STARBUCKS SITE IMPROVEMENTS

ROBERT B. AIKENS AND ASSOCIATES
 350 N. OLD WOODWARD
 SUITE 300
 BIRMINGHAM, MI 48009
 TELE: 248-283-2387
 CONTACT: JAMES FIELDER
 EMAIL: fielder@rbaikens.com

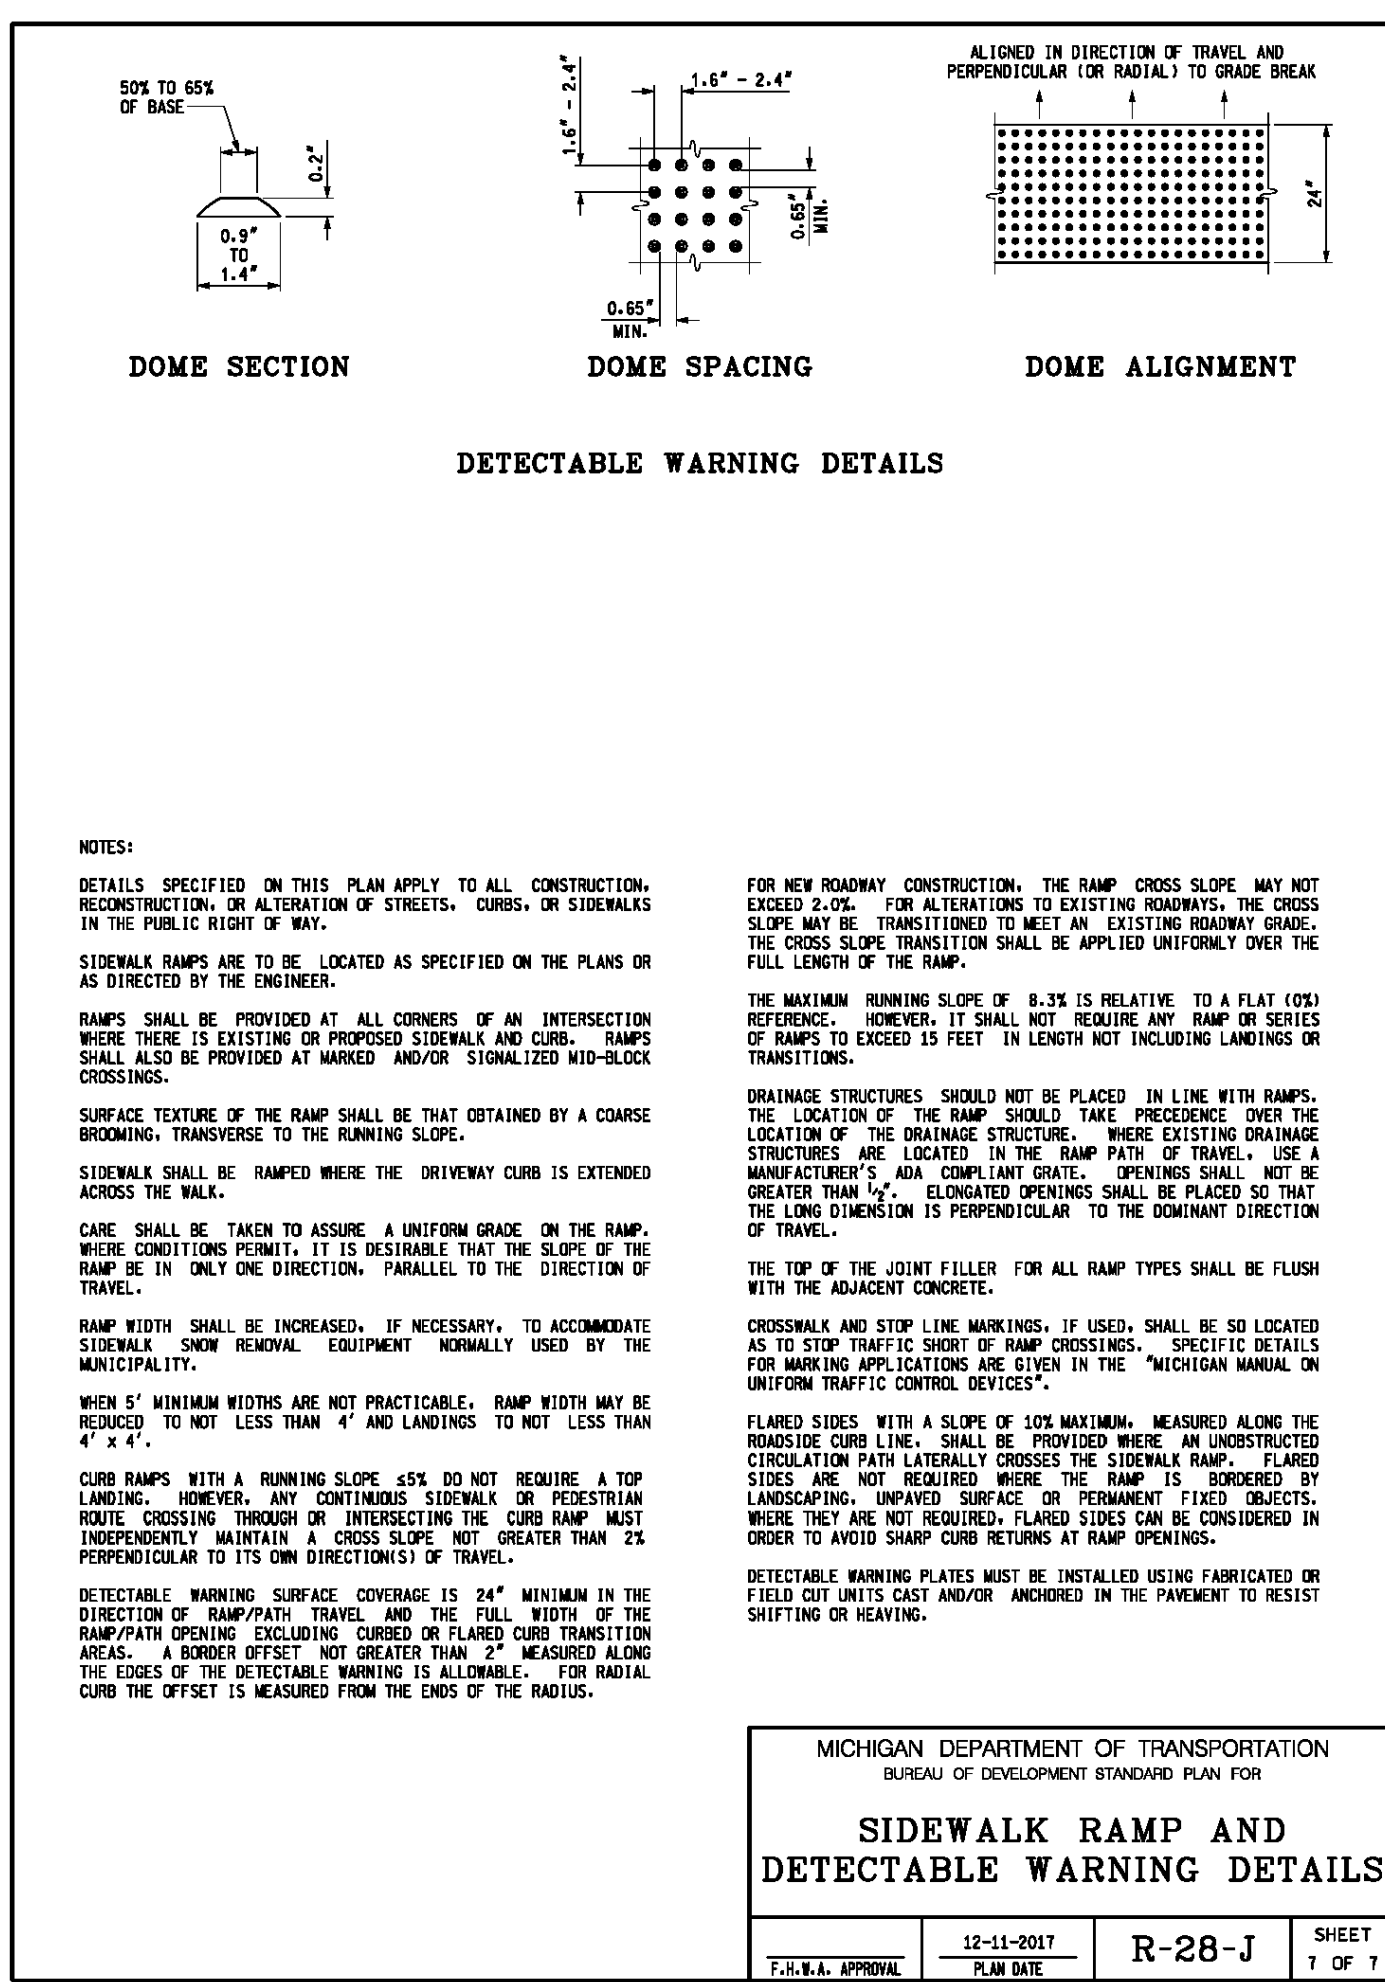
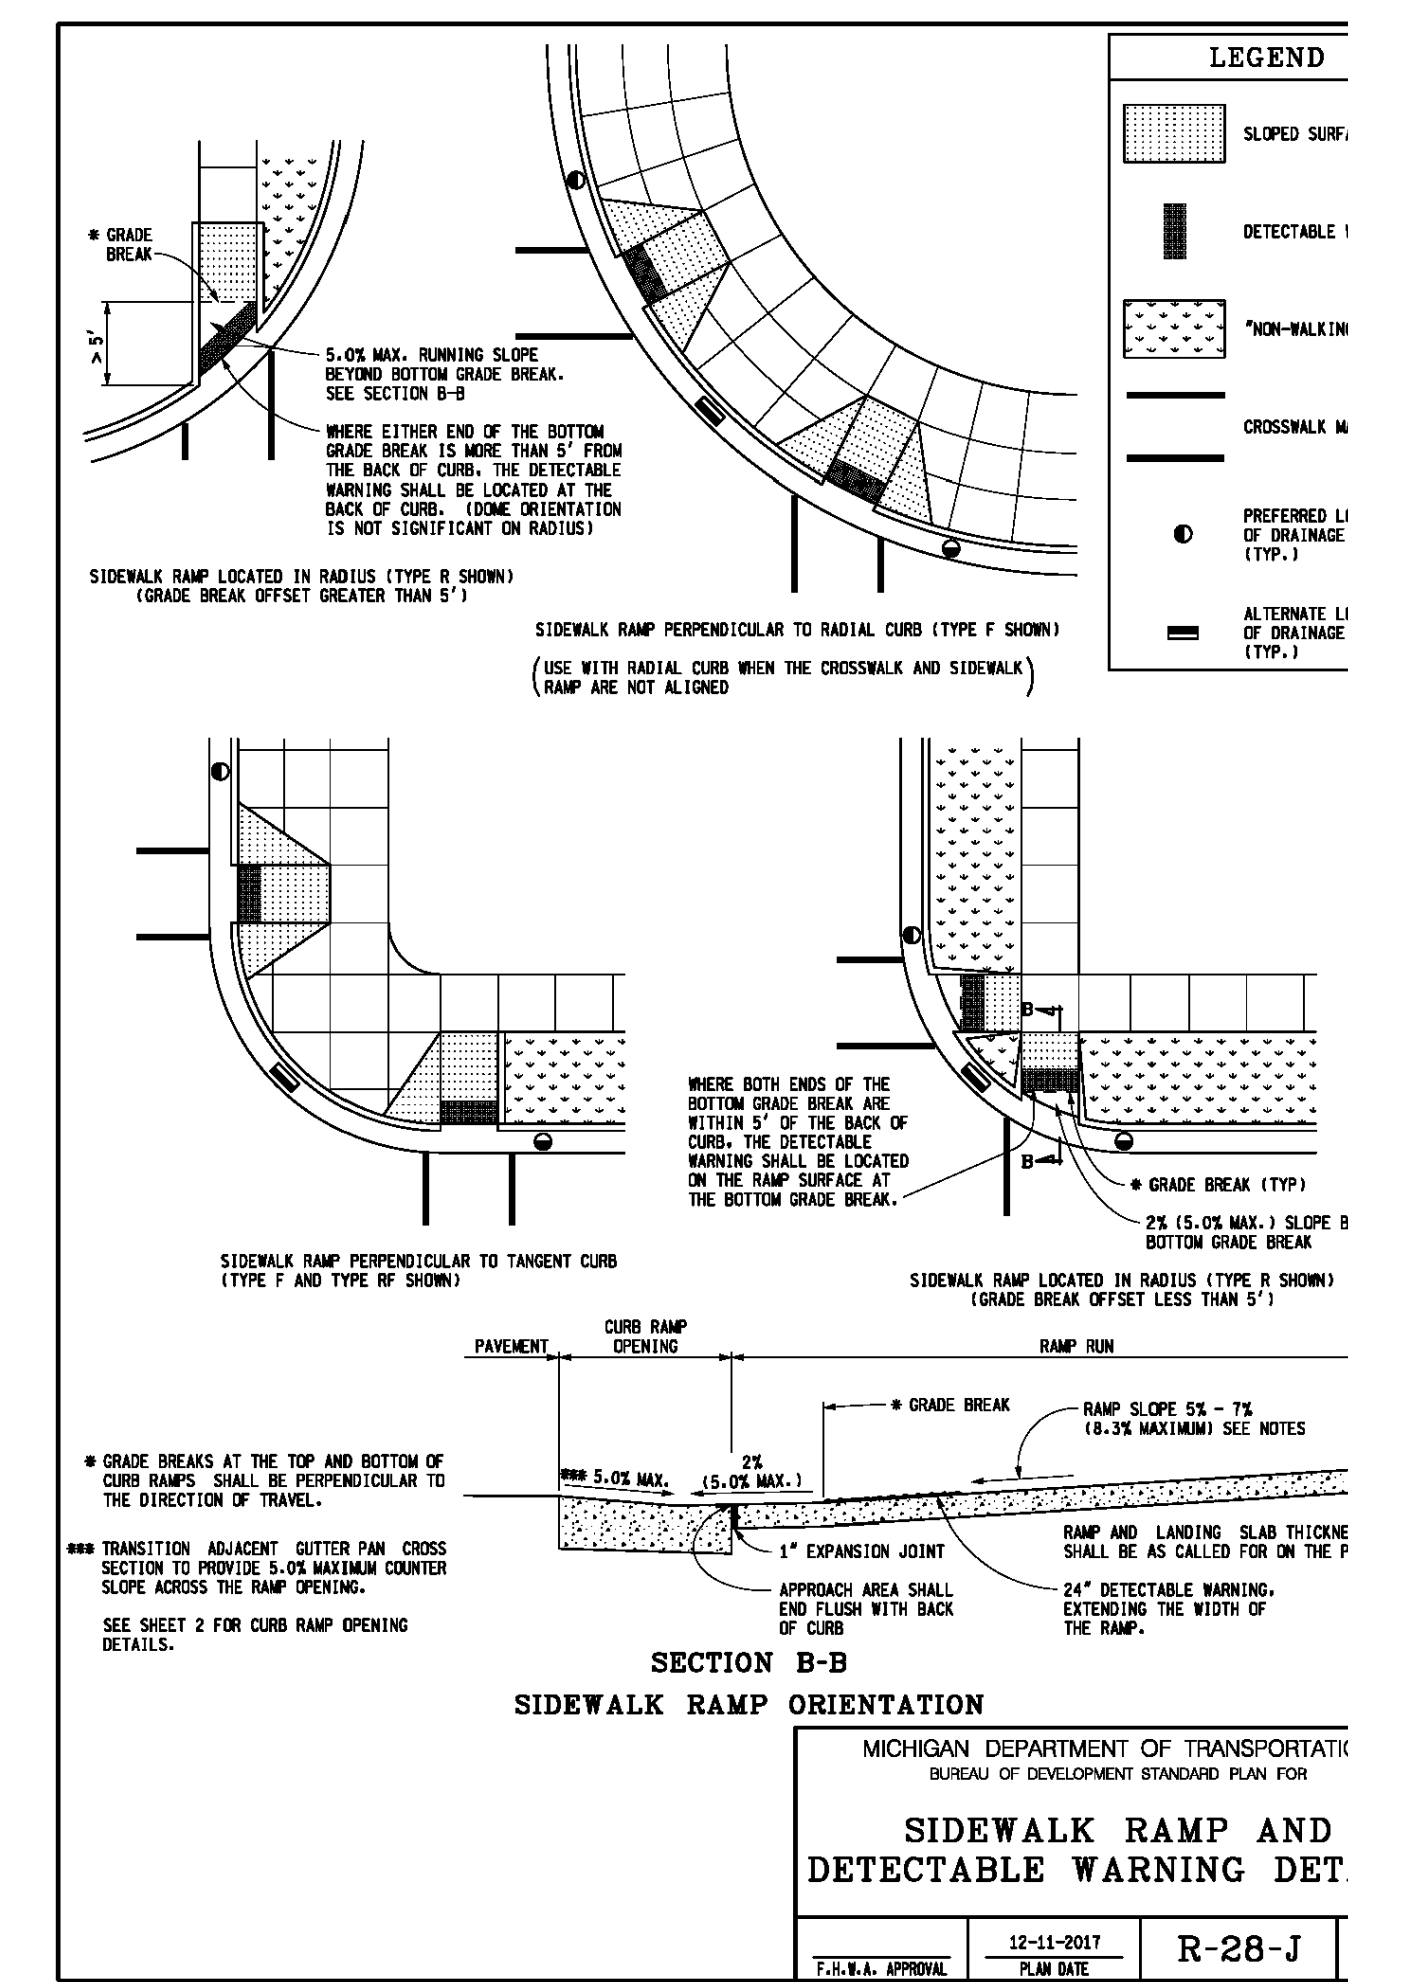
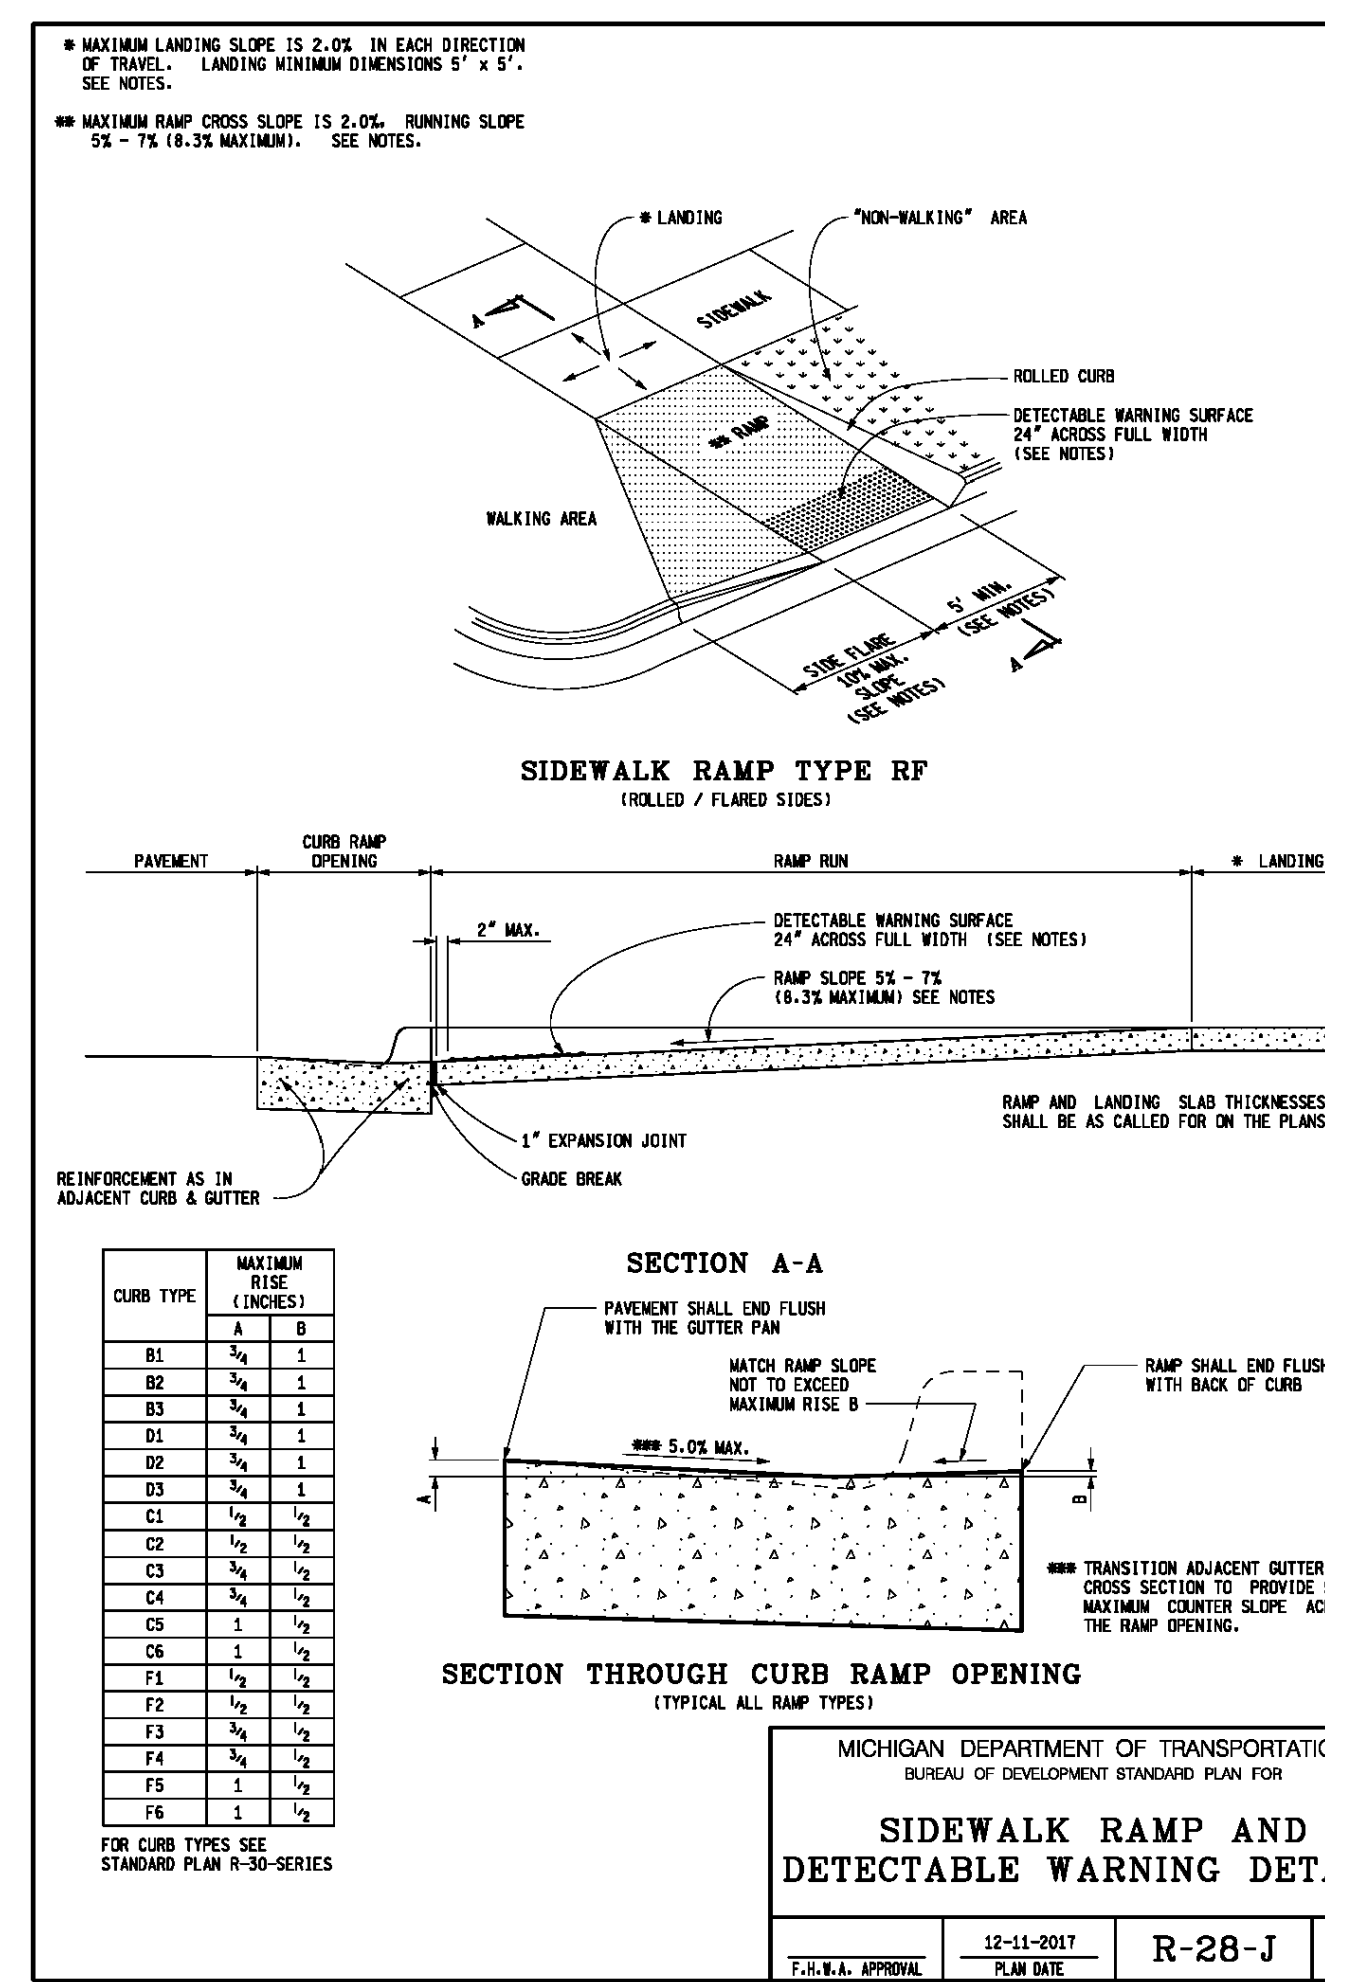
CAR	REVISED PER CITY REVIEW COMMENTS	2-3-22
BY	MARK	DATE
